PCN-20230524 TE0813-01 to TE0813-02 Hardware Revision Change

Company	Trenz Electronic GmbH
PCN Number	PCN-20230524
Title	TE0813-01 to TE0813-02 Hardware Revision Change
Subject	Hardware Revision Change
Issue Date	2023-06-27

#20 Signal trace lengths changed

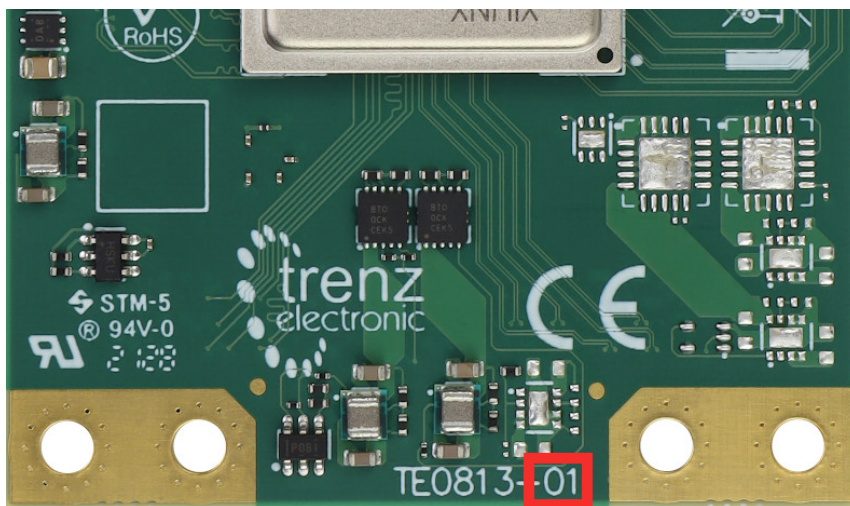
Impact: Changed trace length have to be taken into account in existing designs. The trace length for new revision will be available in [TE081x series pinout generator](#). Please check if change in trace length still matches your requirements. Adaption of carrier may be necessary.
